SITE PLAN

for : MORELAND CONSTRUCTION CLIENT

8865 SANCTUARY DRIVE ADDRESS KIRTLAND HILLS CITY

1 CONCORD TOWNSHIP OHIO

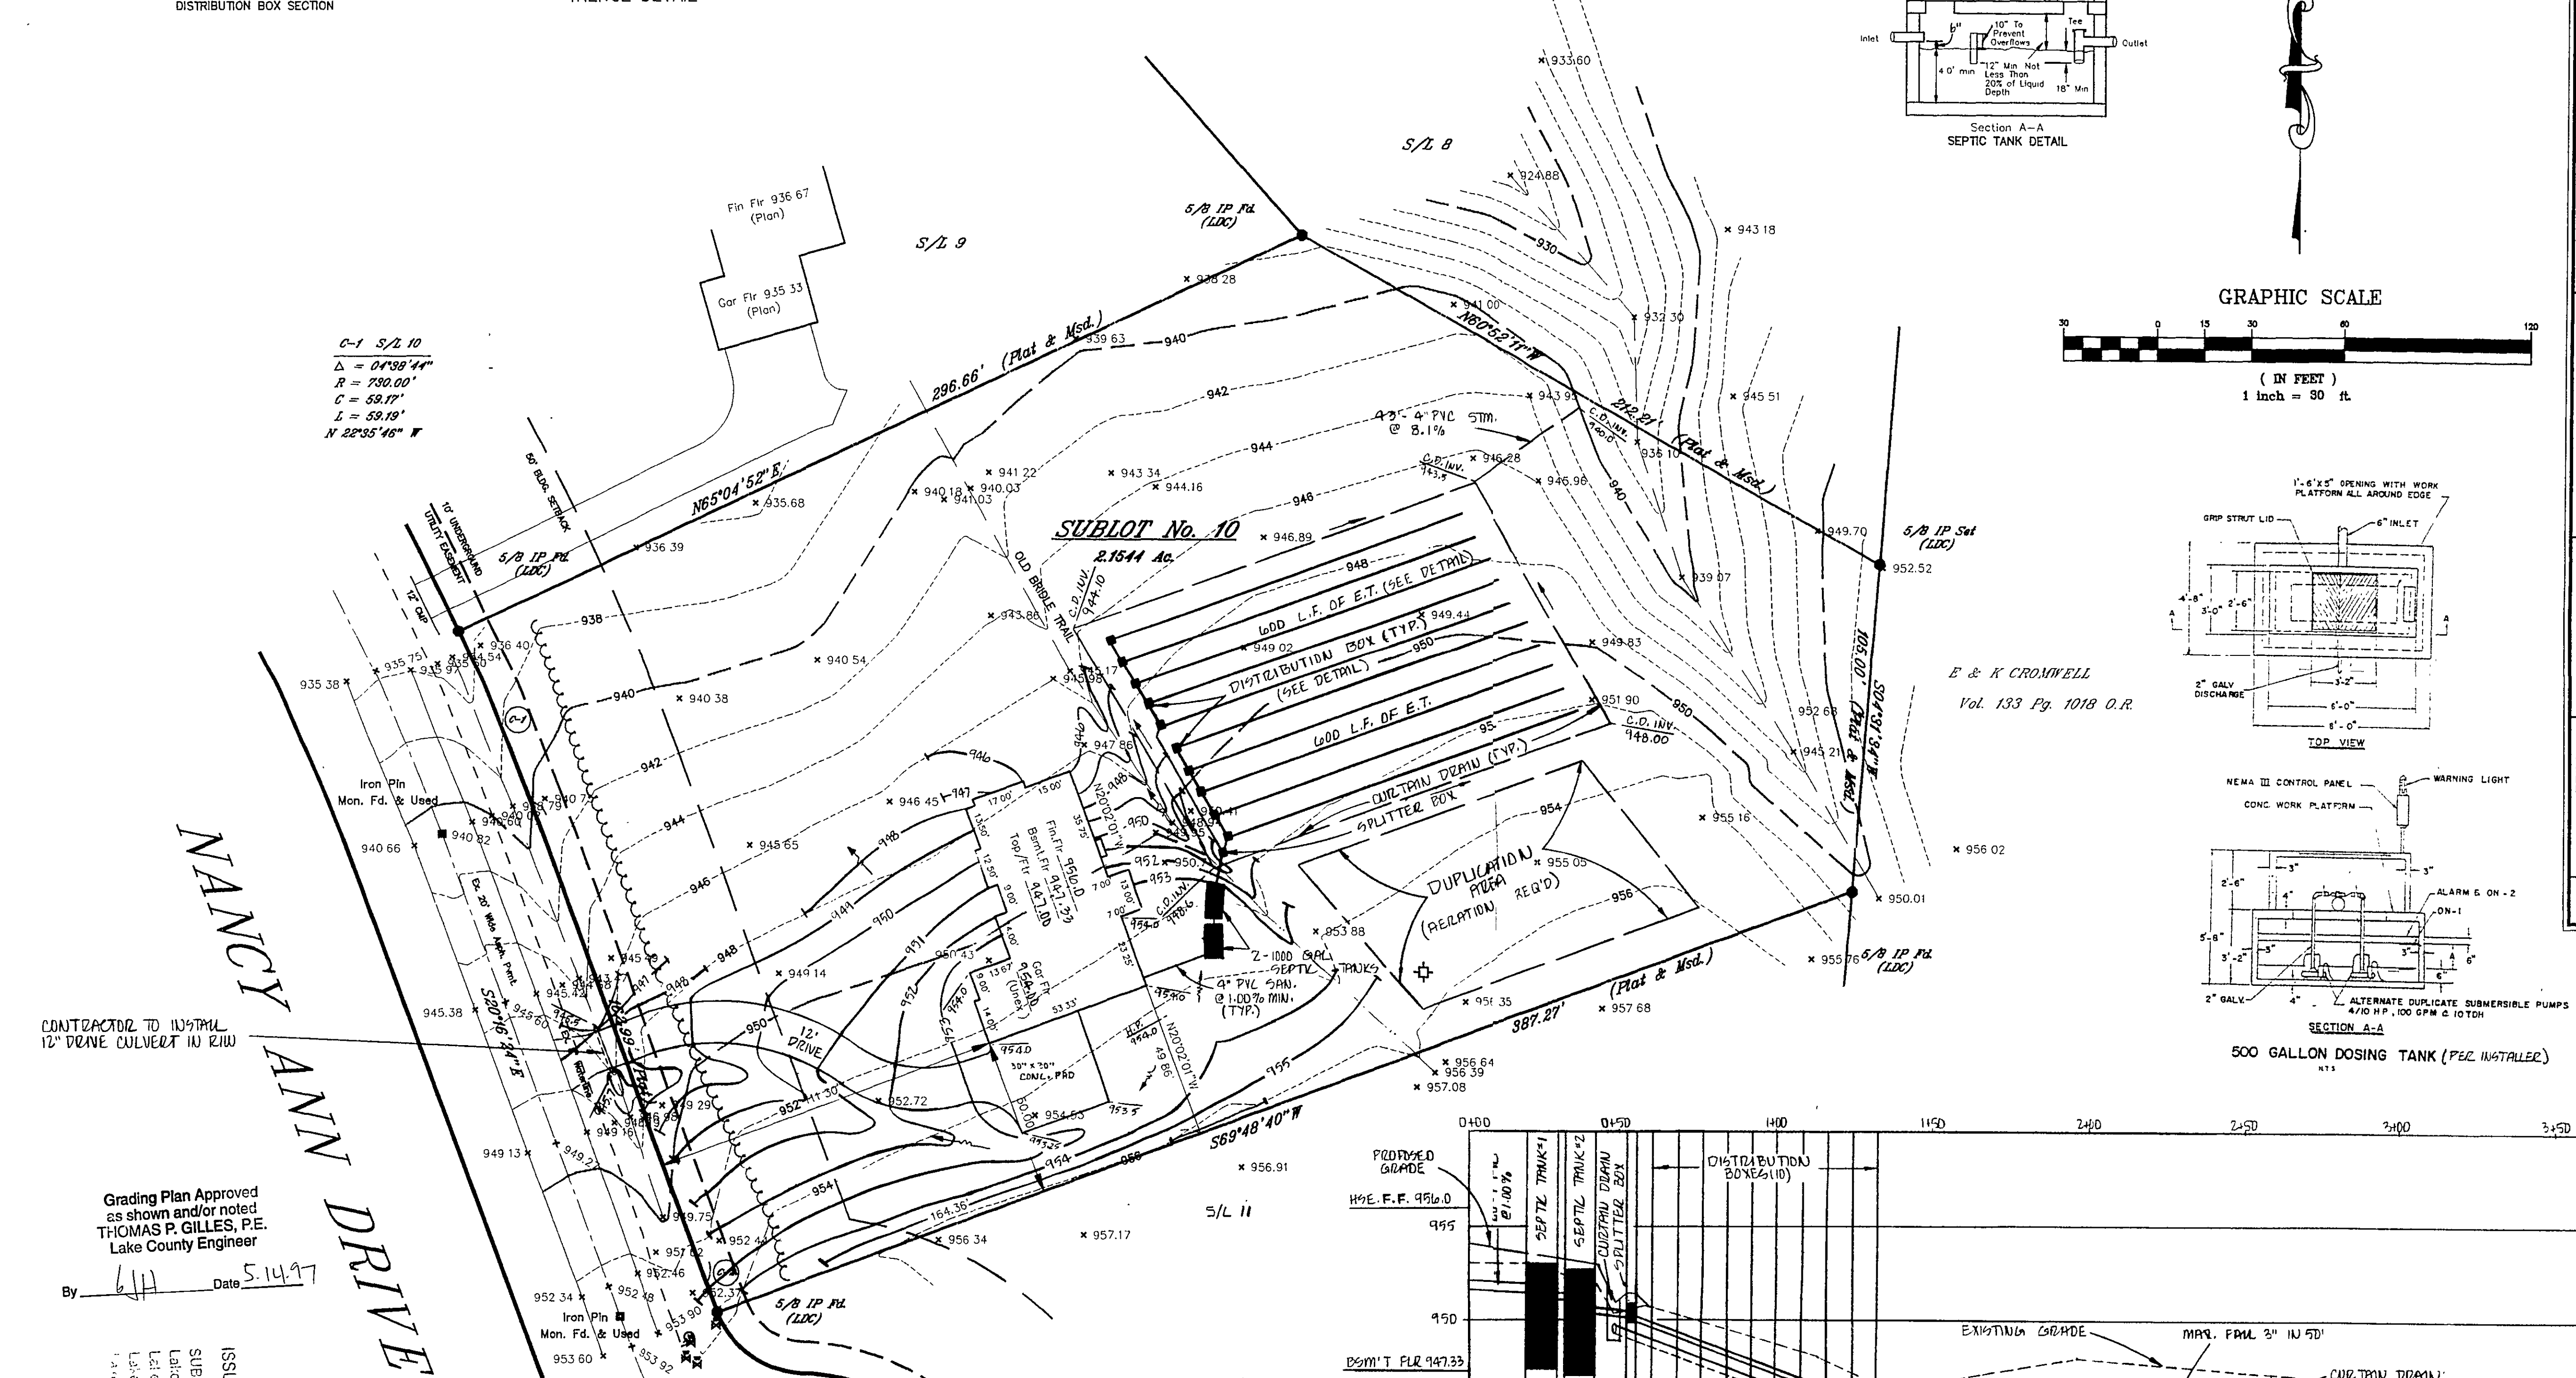
CONTRACTOR TO INSTALL 12" DRAIN CULVERT IN ROW
